UNITED STATES PATENT AND TRADEMARK OFFICE

Office Action Summary	Application No. 10/829,485	Applicant(s) MANTELL, ROBERT R.	
	Examiner Manuel A. Mendez	Art Unit 3763

DETAILED ACTION

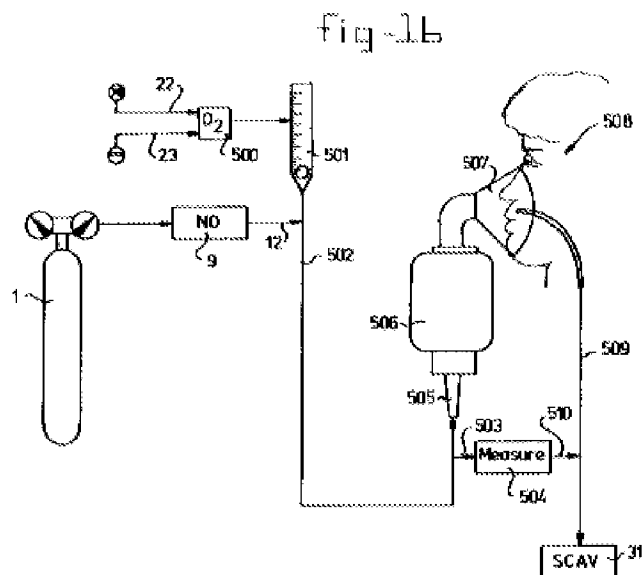
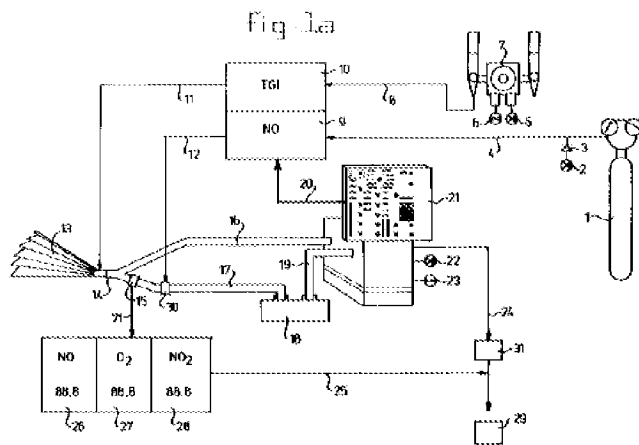
Claims 1-4 and 9-11 are rejected under 35 U.S.C. 102(b) as being anticipated by **Lugtigheid et al.**

The cited patent shows in figure 1b, a gas supply providing at least two sources of gas and a mixer system having a chamber and two inlets and one outlet wherein the two inlets of the chamber are in fluid communication with the gas supply and the chamber.
